**PLANNED UNIT DEVELOPMENT
& SUBDIVISION STAFF REPORT****Date: June 15, 2006**

DEVELOPMENT NAME Grant Park Subdivision, Resubdivision of Lots 47 & 48

CONTEMPLATED USE 1-lot, residential subdivision, and Planned Unit Development Approval to amend a previously approved Planned Unit Development Approval to allow reduced lot sizes, reduced building setbacks, and increased site coverage in a residential subdivision.

SITE PLAN

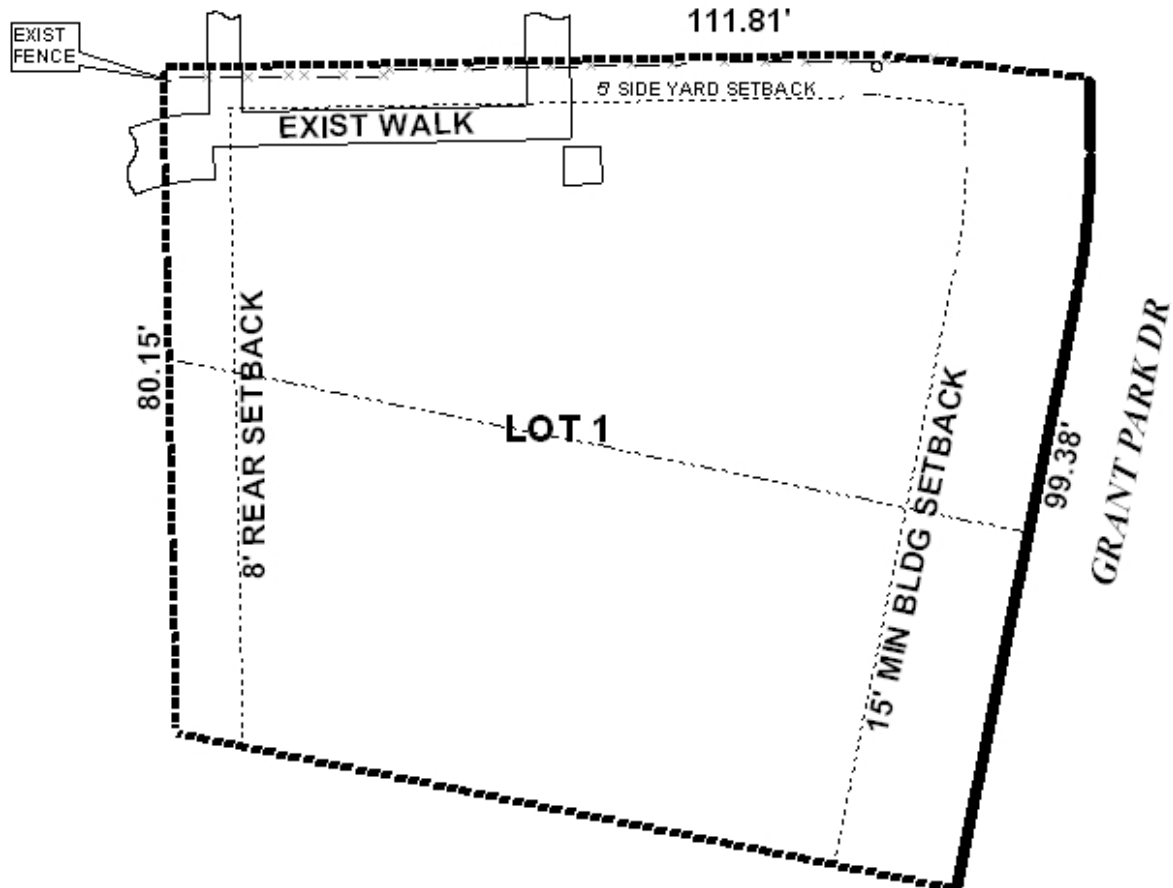
The existing PUD allows a 15-foot front yard setback, 0-foot South side yard setback, 5-foot North side yard setback, and an 8-foot rear yard setback. These setbacks are graphically depicted on the preliminary plat and proposed site plan, however, they should also be noted in writing on the preliminary plat and proposed site plan, to ensure conformance with the existing PUD.

RECOMMENDATION: **Planned Unit Development:** Based on the preceding, the PUD application is recommended for Approval, subject to the following conditions: 1) completion of the Subdivision process; 2) placement of a note on the plat / site plan specifying the front, side and rear yard setbacks, to comply with the original PUD and Subdivision; 3) placement of a note on the site plan and plat stating that the site is limited to a maximum 45% site coverage; 4) placement of a note on the site plan and plat stating that common areas are to be maintained by the property owners; 5) placement of a note on the site plan and plat stating that two over-story trees are to be planted within the 25-foot frontage of the lot along the city street; and 6) full compliance with all municipal codes and ordinances.

Subdivision: Based on the preceding, the plat is recommended for Tentative Approval, subject to the following conditions: 1) placement of a note on the plat / site plan specifying the front, side and rear yard setbacks, to comply with the original PUD and Subdivision; 2) placement of a note on the site plan and plat stating that the site is limited to a maximum 45% site coverage; 3) placement of a note on the site plan and plat stating that common areas are to be maintained by the property owners; 4) placement of a note on the site plan and plat stating that two over-story trees are to be planted within the 25-foot frontage of the lot along the city street; and 5) full compliance with all municipal codes and ordinances.
